Access Compliance Report Public Rights-of-Way (Curb Ramps)

Main Street: CERNER_CT Cross Street: ELLISTON_DR Location: NE

ADA ID: RPRK211027114838 Ramp Type: Type 4 - Parallel Initial Pass/Fail: Pass Overall Compliance: No Severity Score: 25

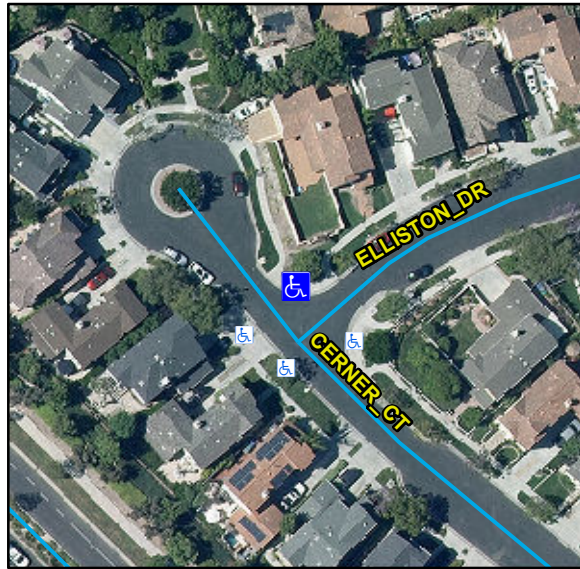
R304.2.2, R204.3, R304.2.1, R304.2.2-Perp, R304.3.2-Para, R304.5.3, R305, R302.7.2, R304.5.4, STD 1115

Remove & Replace Curb Ramp With Two New Directional Ramps or Equivalent. Remove & Replace Gutter.
